ALLAMAKEE CSD MIDDLE SCHOOL HVAC UPGRADE
WAUKON, IOWA

ADDENDUM 02
March 6, 2026

MECHANICAL
PIPING &
CONTROLS PLAN -
AREA B

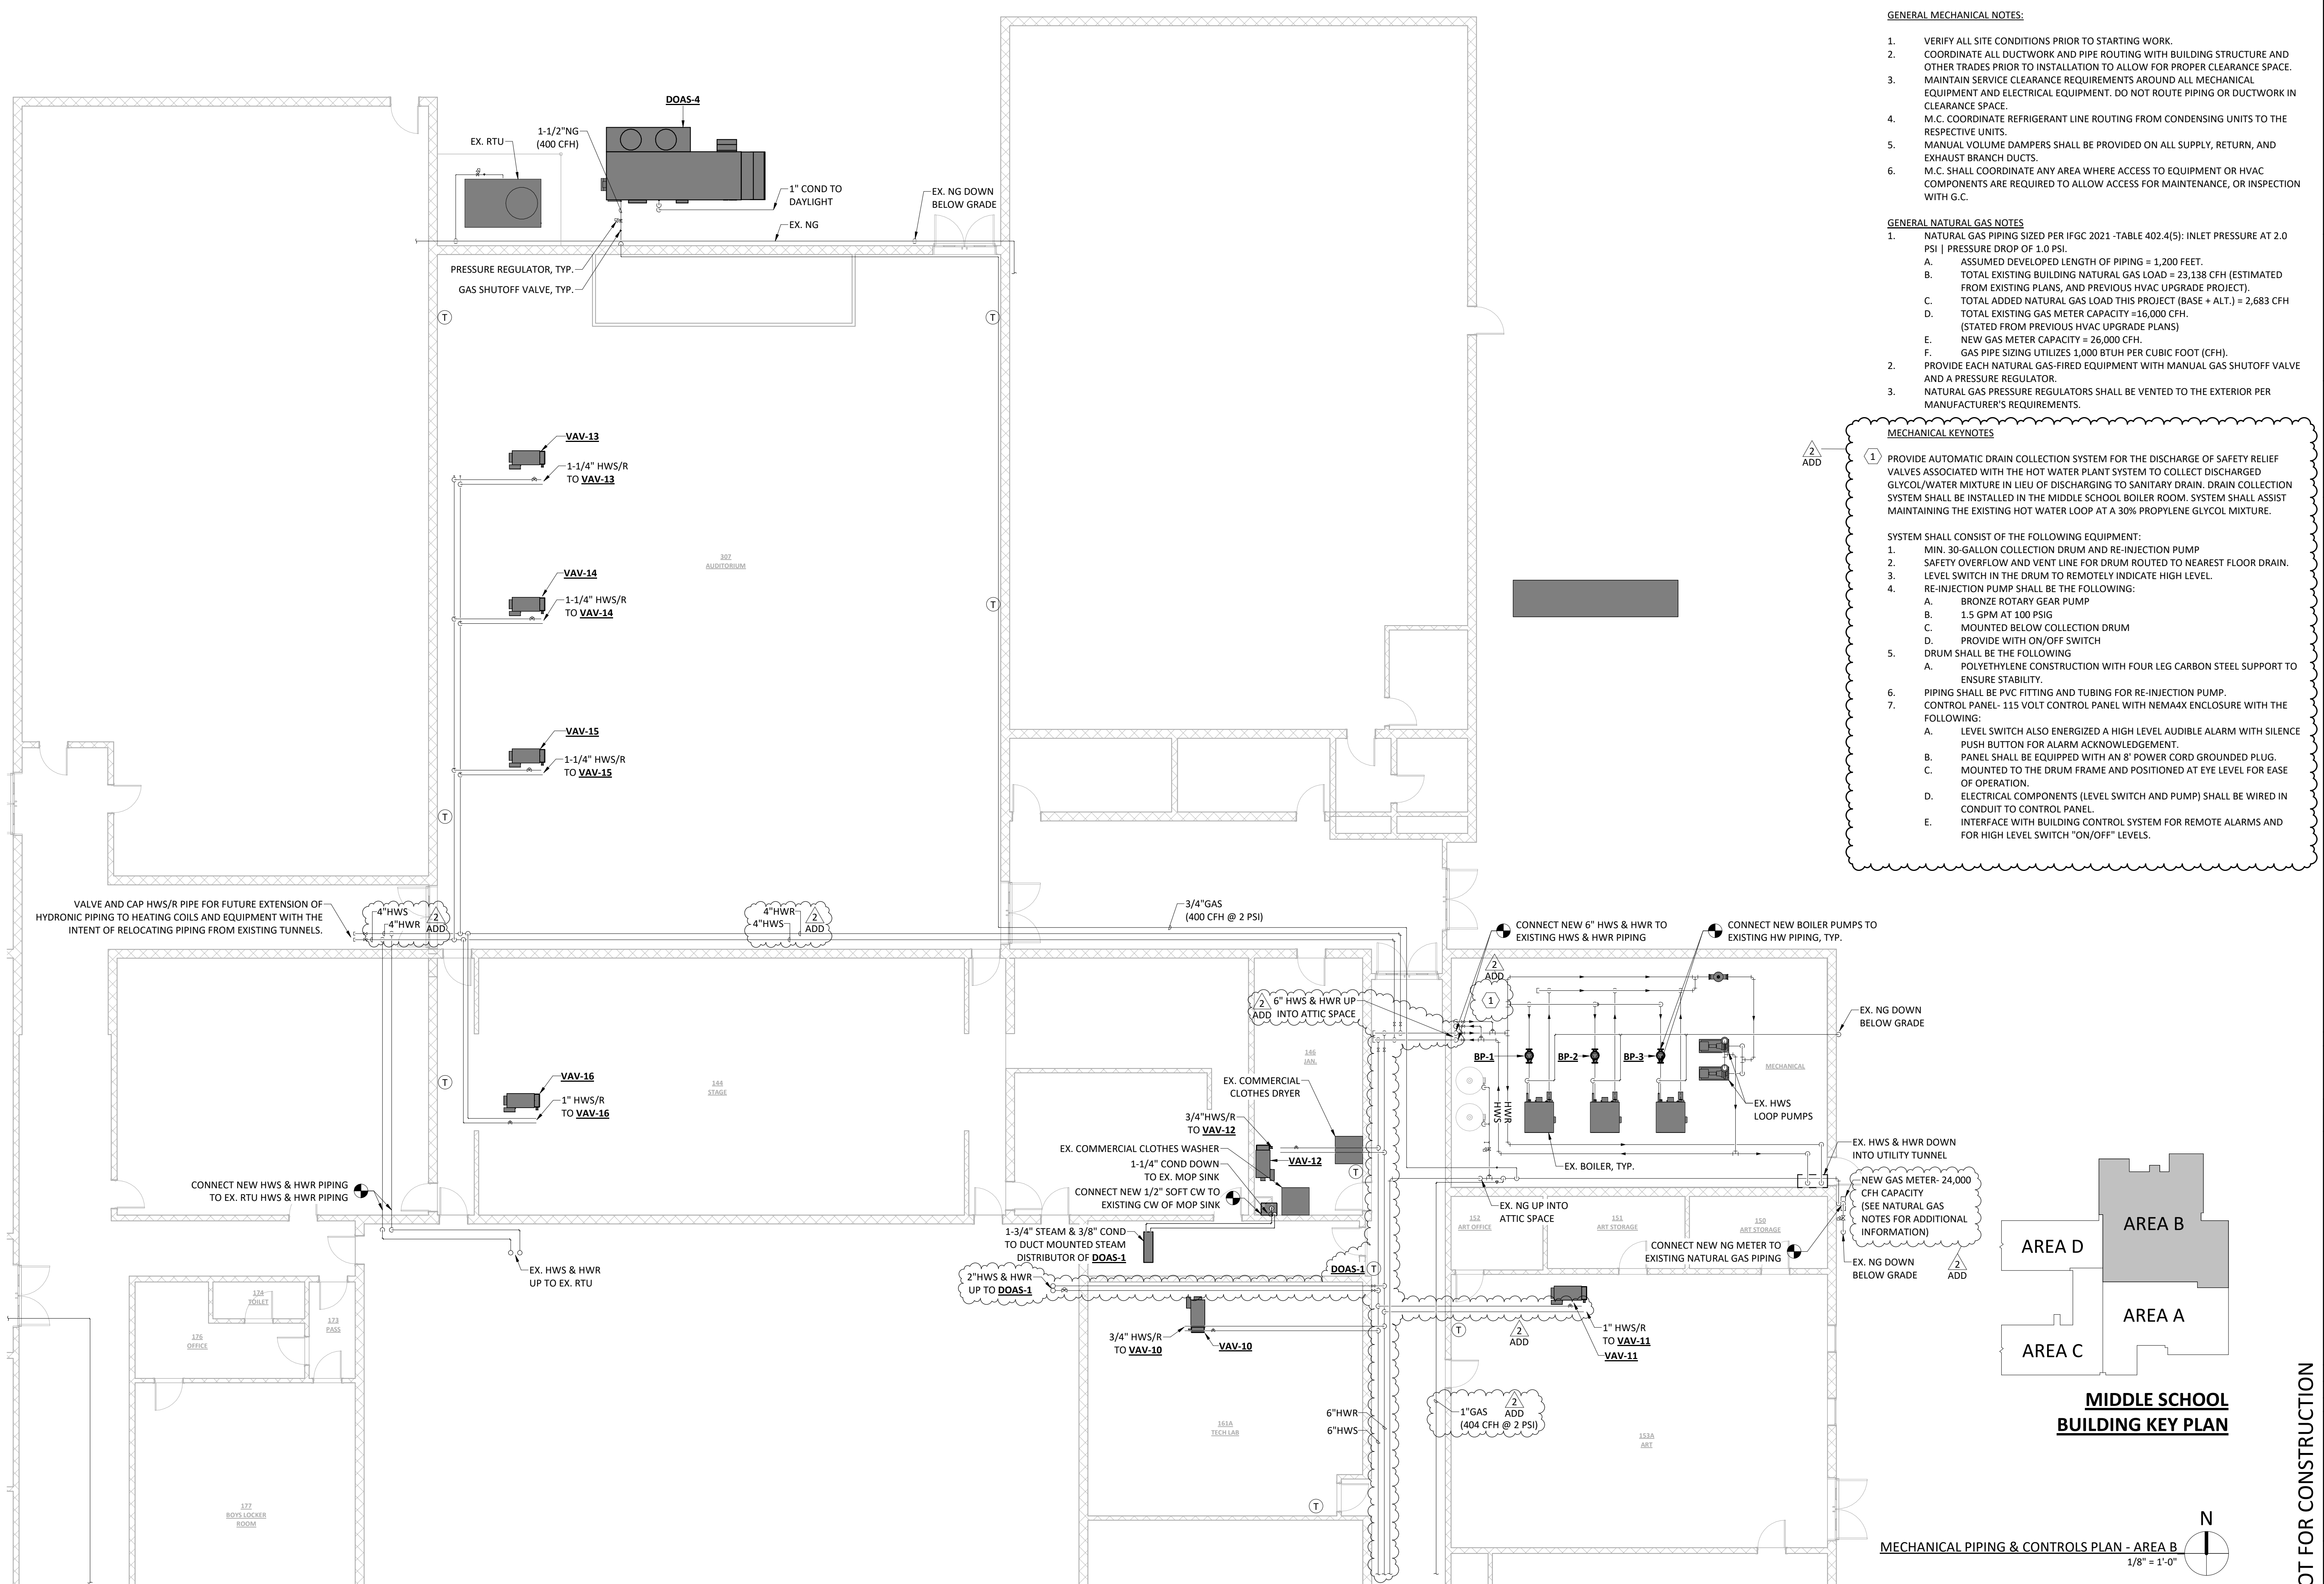
- M2-4 Drawing **M-111B – MECHANICAL PIPING & CONTROLS PLAN – AREA B**
1. Added Mechanical Keynote 1 describing automatic drain collection system within Mechanical room.

2. Removed gas piping to DOAS units DOAS-1, DOAS-2, DOAS-3, DOAS-5, & DOAS-6.
 3. Updated gas pipe sizing.
 4. Added hot water supply and return piping to DOAS units DOAS-1, DOAS-2, DOAS-3, DOAS-5, & DOAS-6.

5. Revised hot water piping to be routed within attic space.
 6. Added pipe sizing for hot water supply and return piping.
- M2-5 Drawing **M-201 – MECHANICAL ROOF PLAN**

M-801

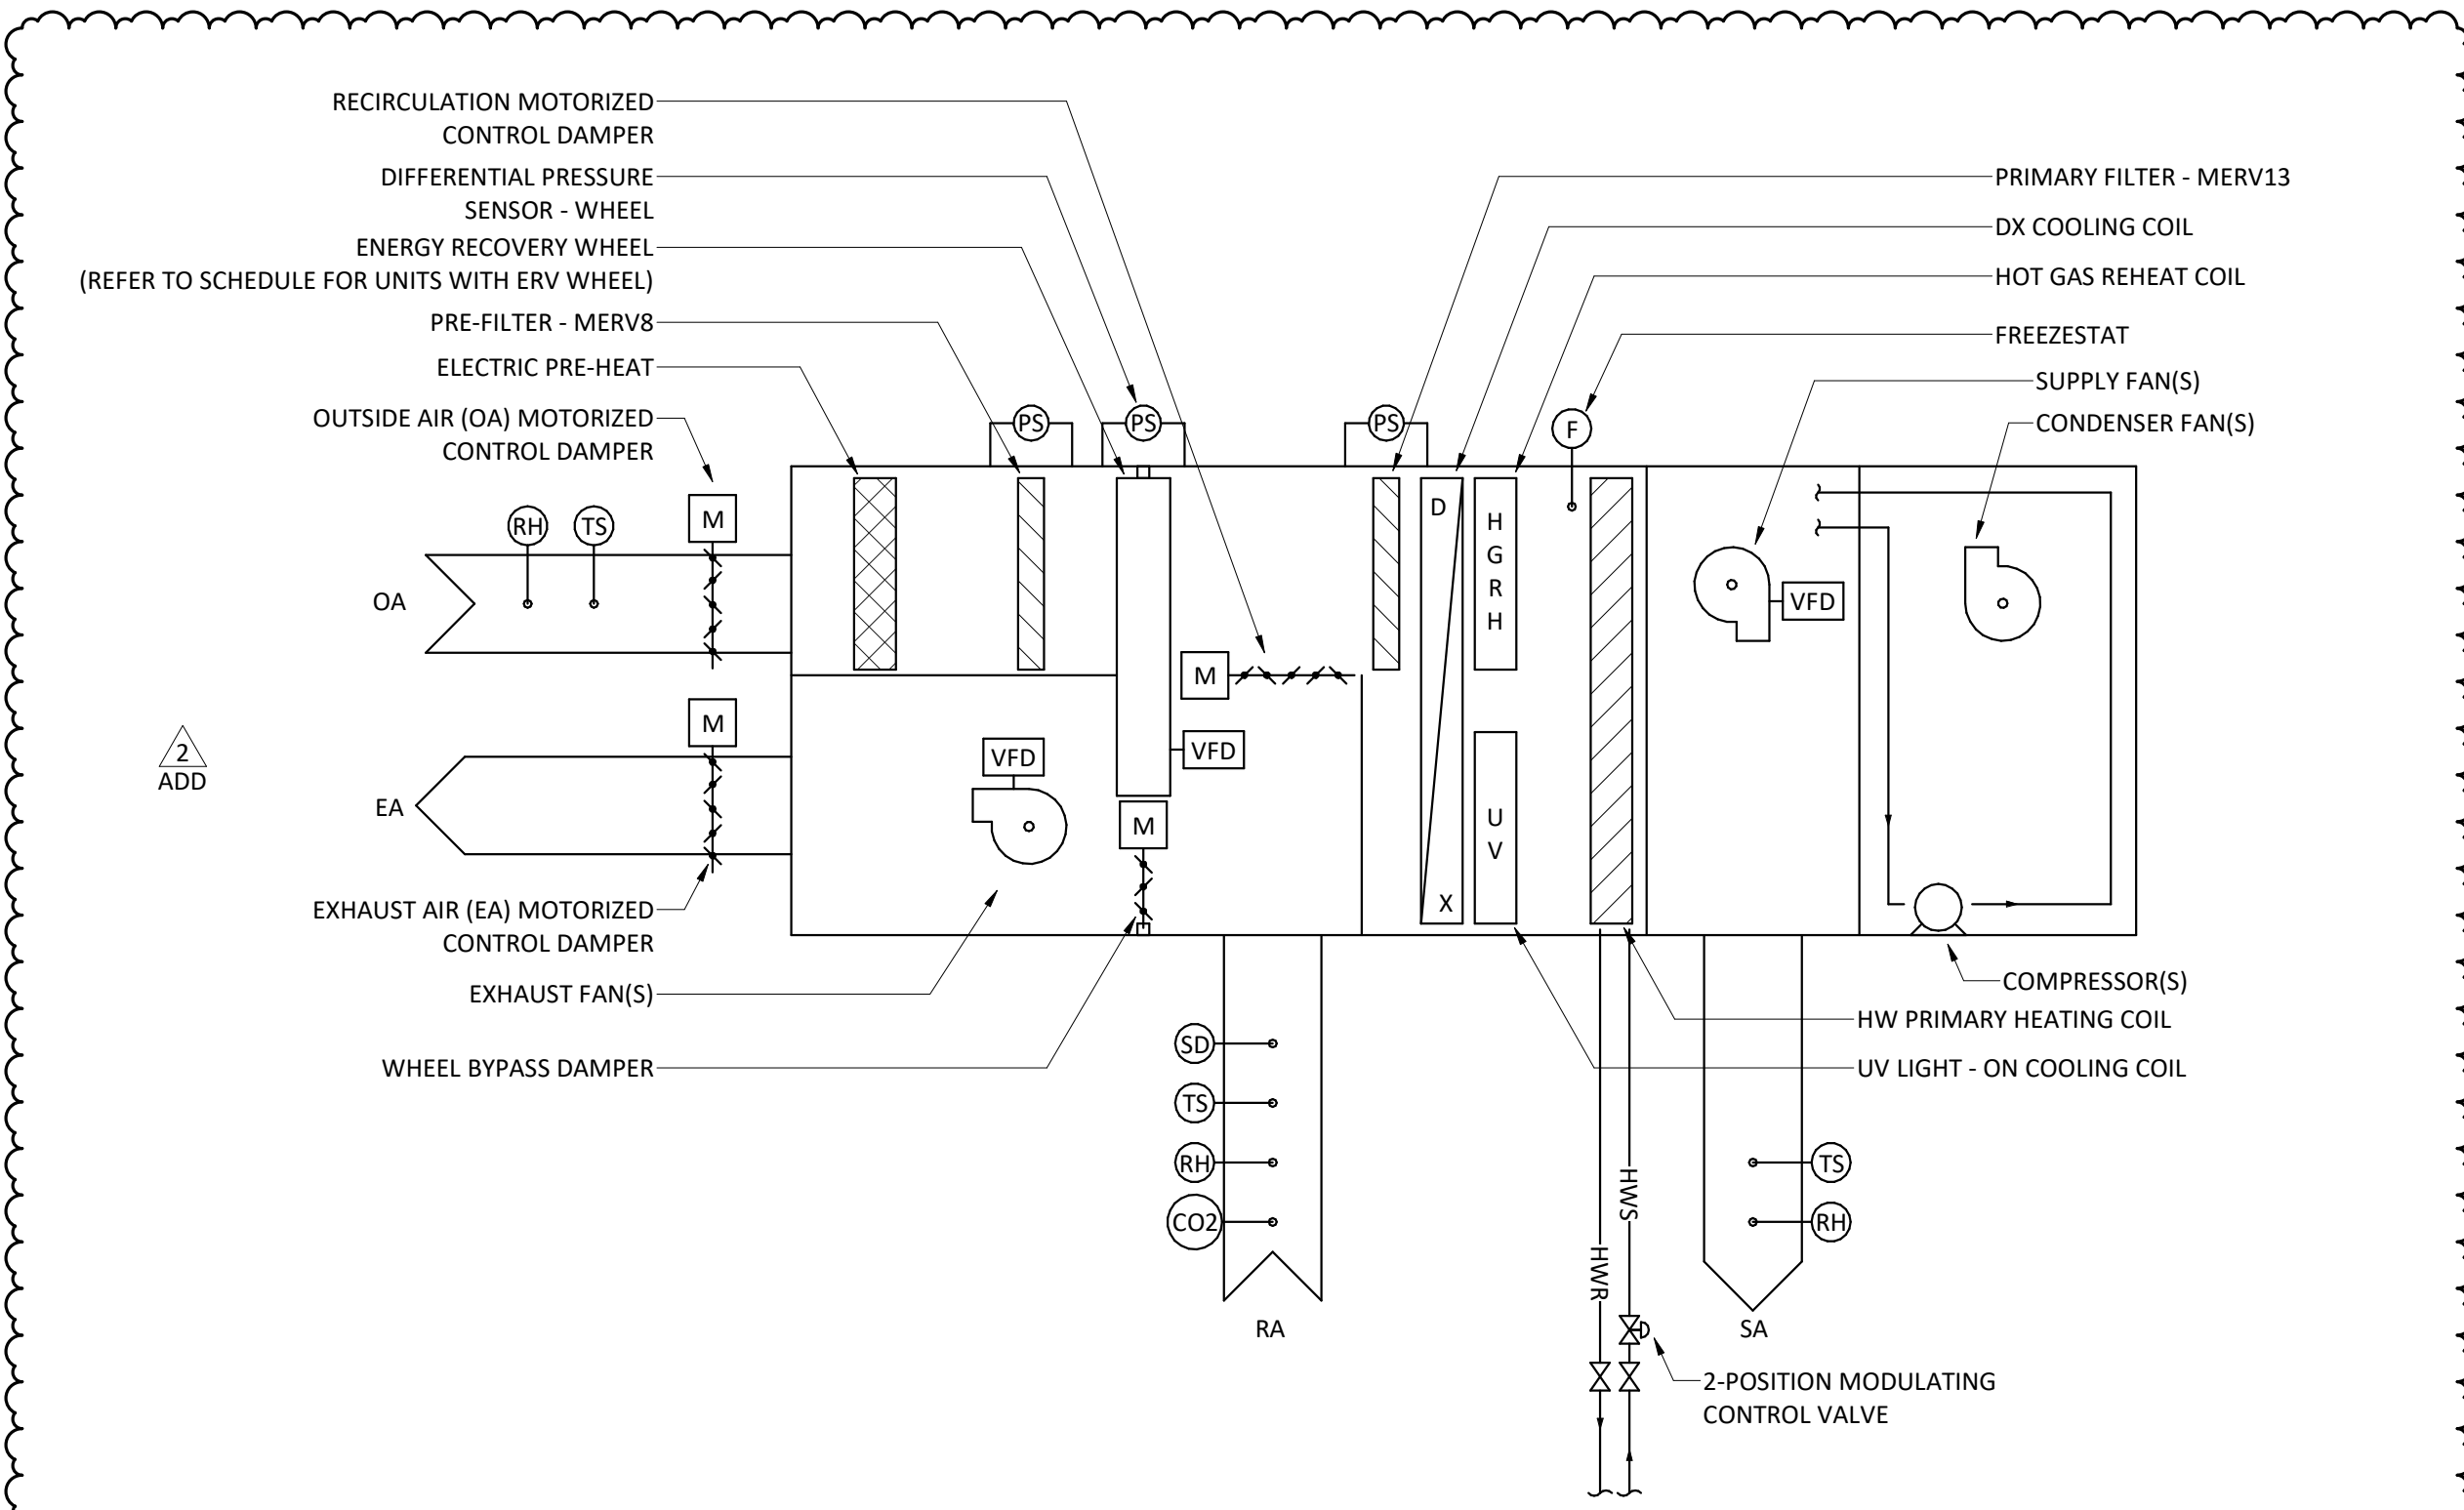
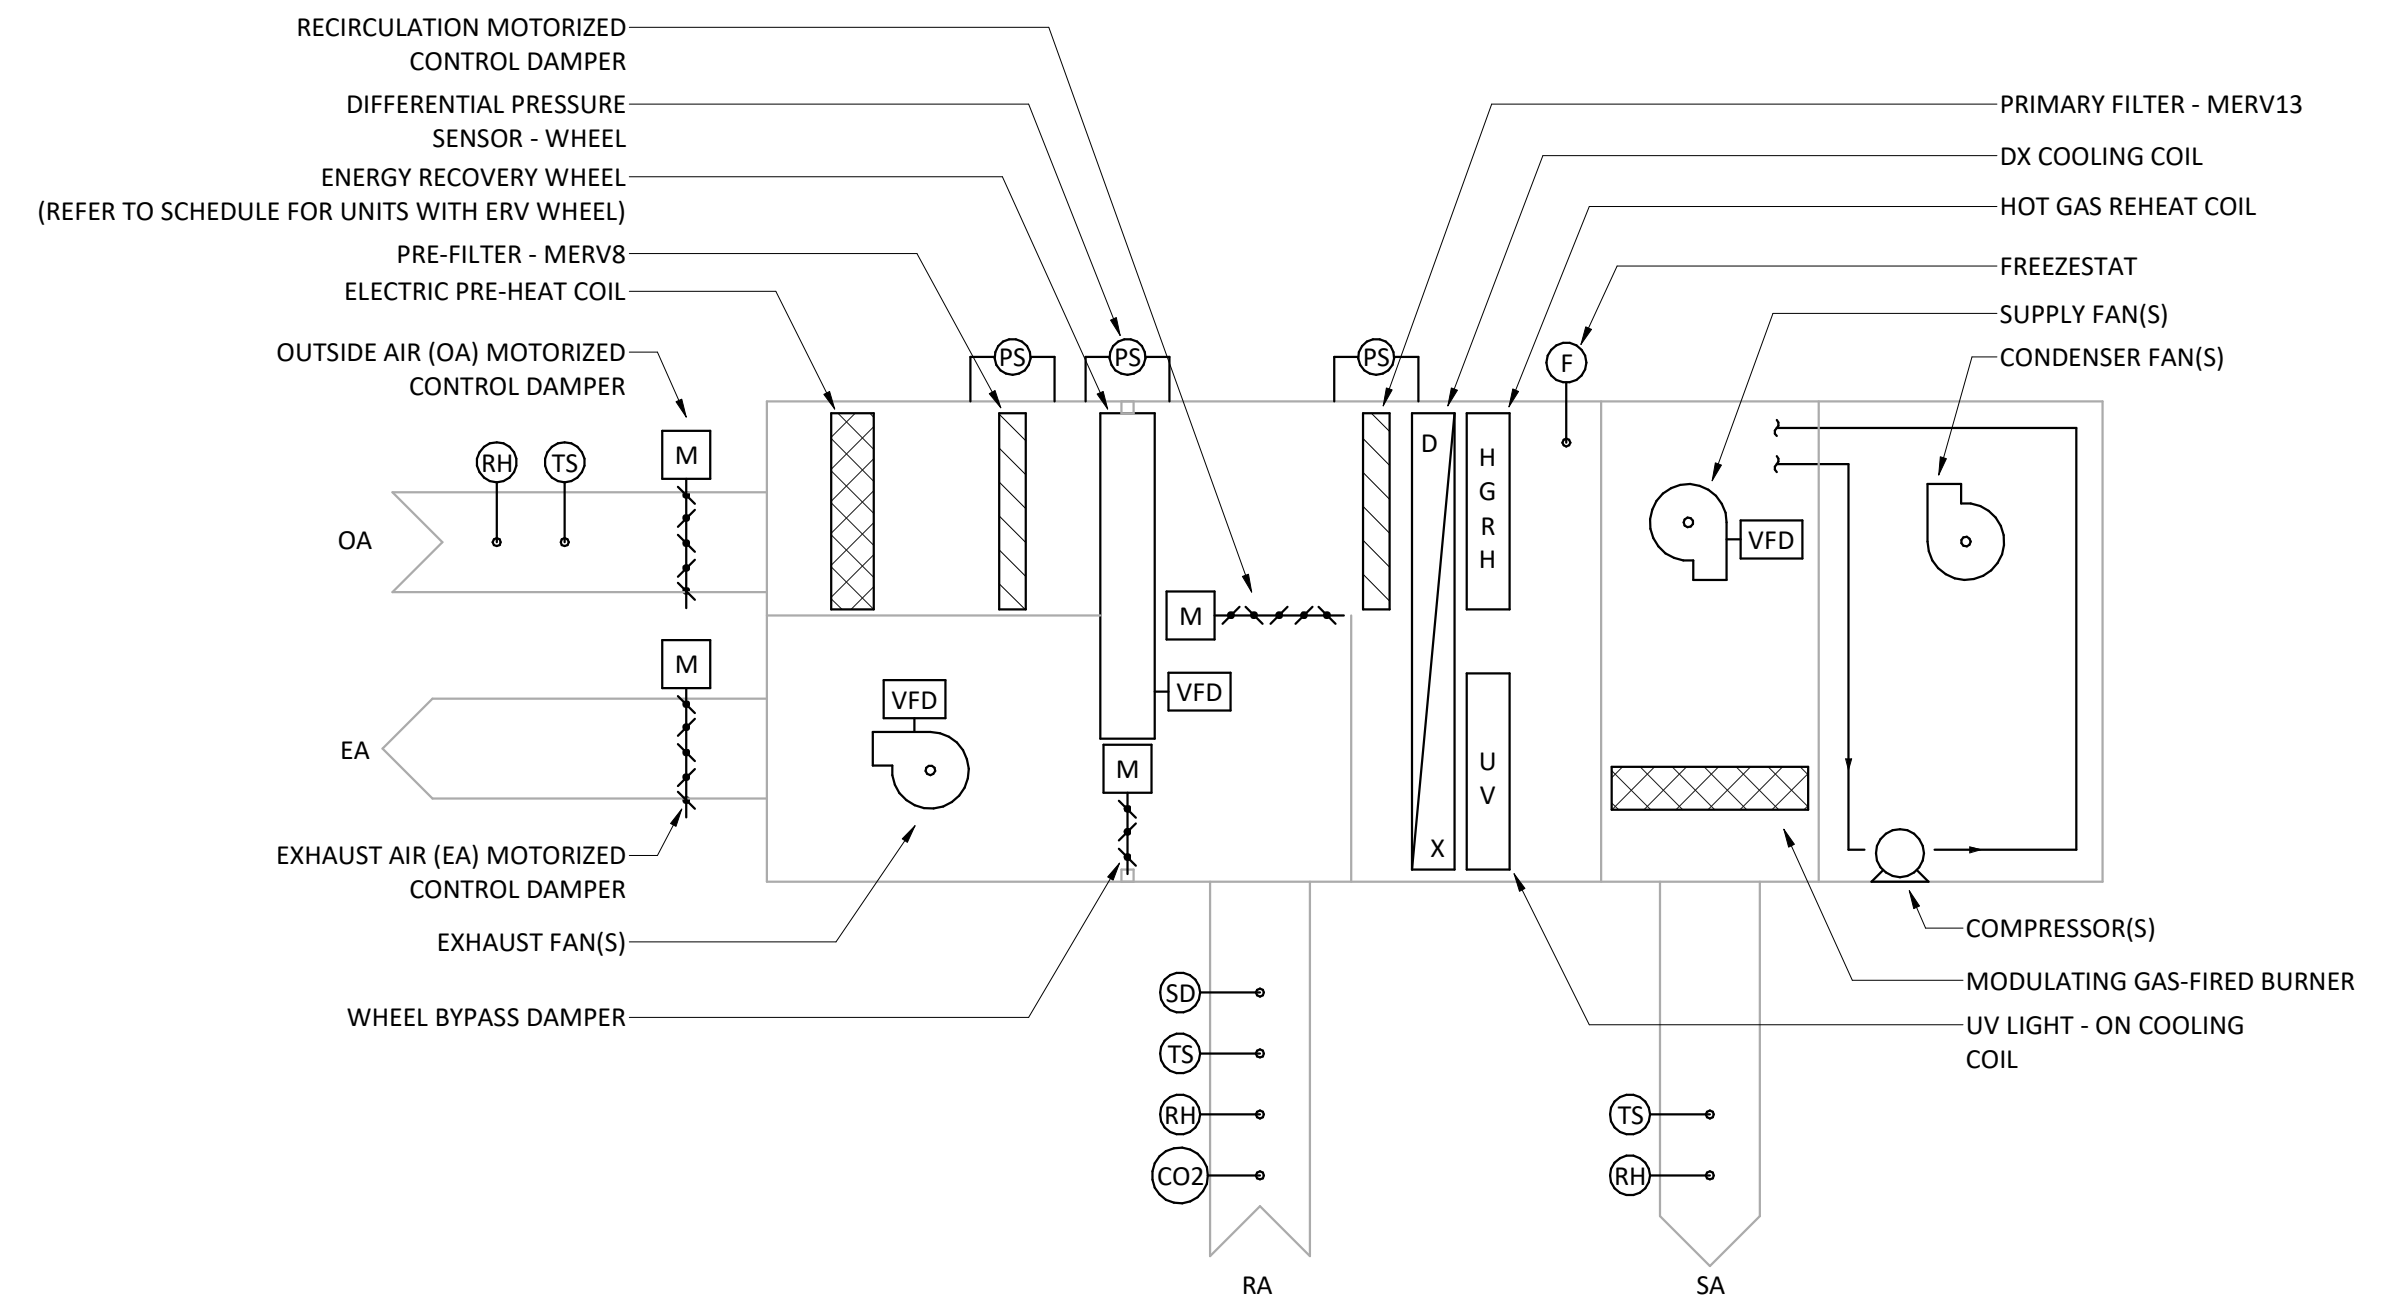
1. Added DOAS Control Diagram for hot water heating units.
 2. Removed not 6 & 10 from gas-fired DOAS Control Diagram sequence.
- ME2-1 Drawing **ME101 – DEMO MECHANICAL & ELECTRICAL PLANS – HIGH SCHOOL**
